# TECHNICAL NOTE 27

## FIBROSCAN 530 TOUCHSENSOR

### ADJUSTMENT

IMAGE 1

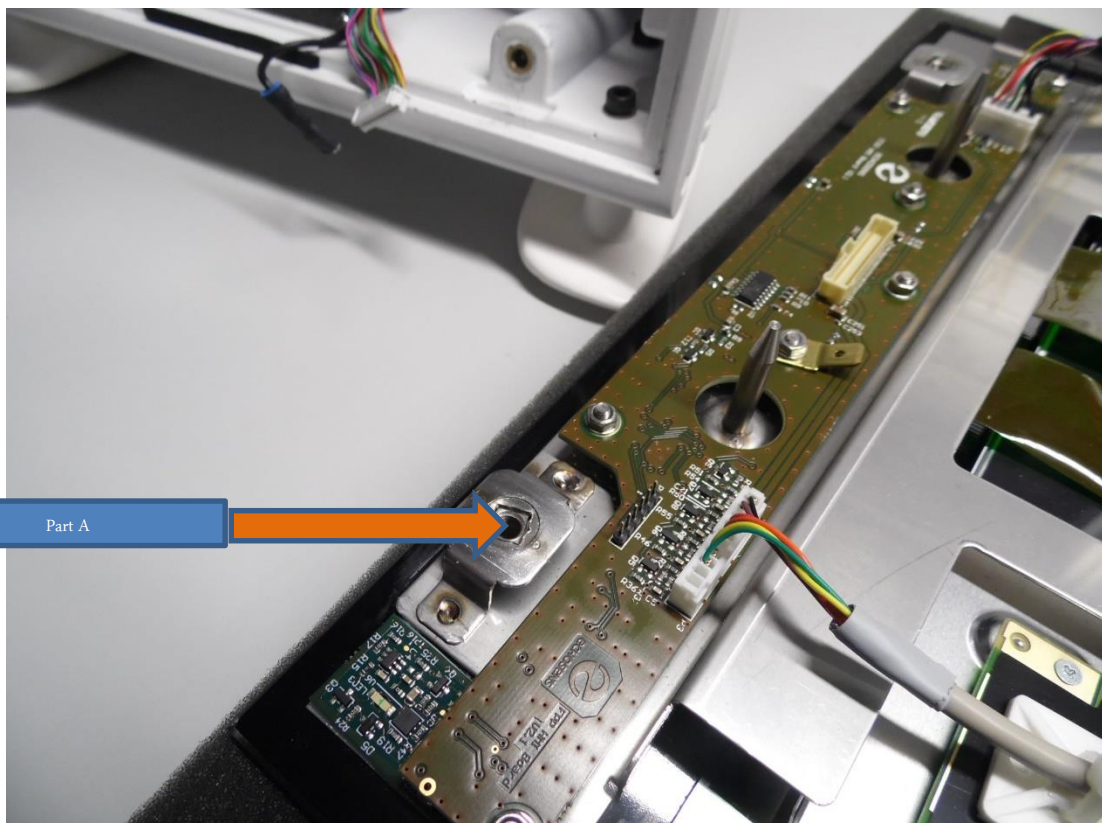
It can be noticed on FibroScan 530 manufactured before June 2016 (F80081) that part A supposed to attach LCD coverglass M300001 to the frame is not deep enough( image 1) .

IMAGE 2

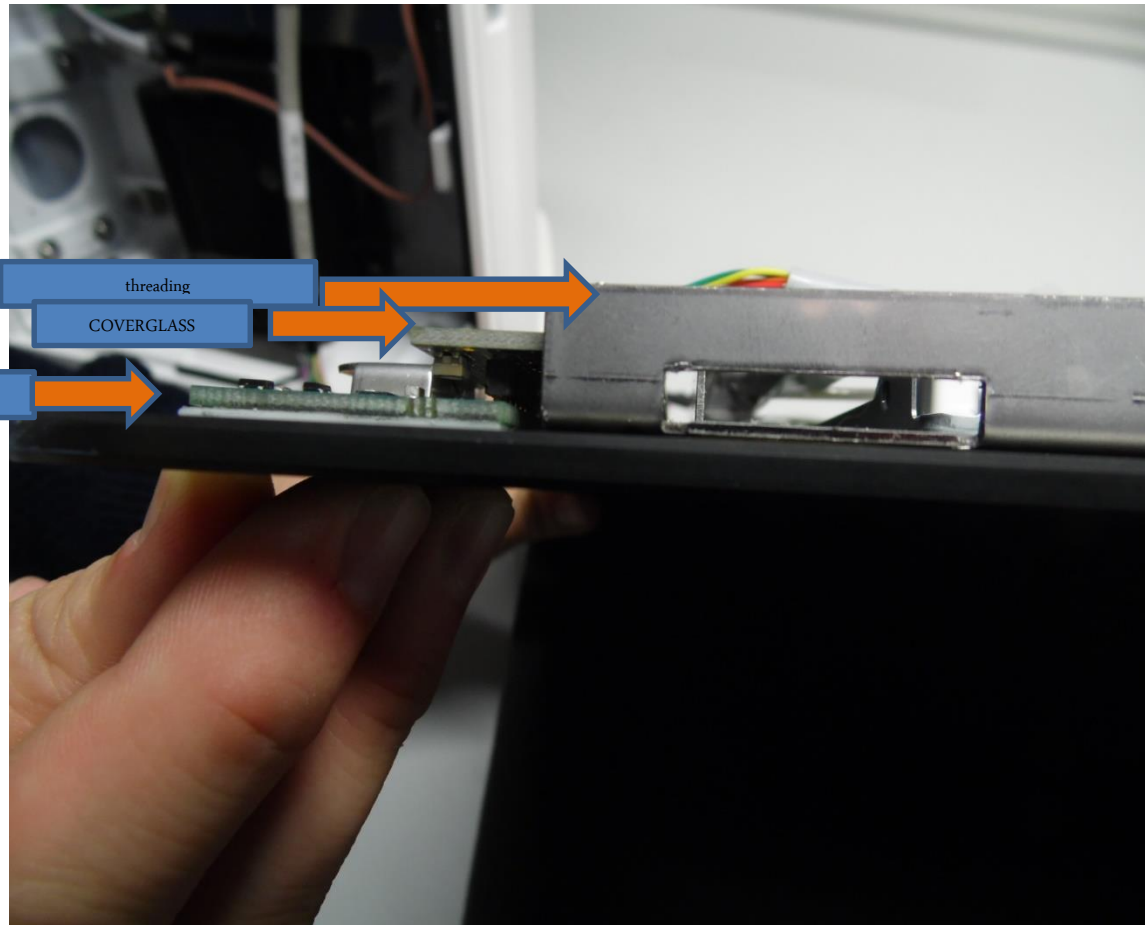
As a consequence the outer cover screw (see E320M003\_2\_TechnicalmanualFibroScan530.docx for assembly details) will pull the metallic frame of the CoverGlass away from the glass and the glue between the frame and the glass might fail; Of this fact, the contact between the HMI board and the Touchscreen PCB (both included in HMI M300017) will become uncertain (image 2) hence the device not turning on/off or turning on/off on its own.
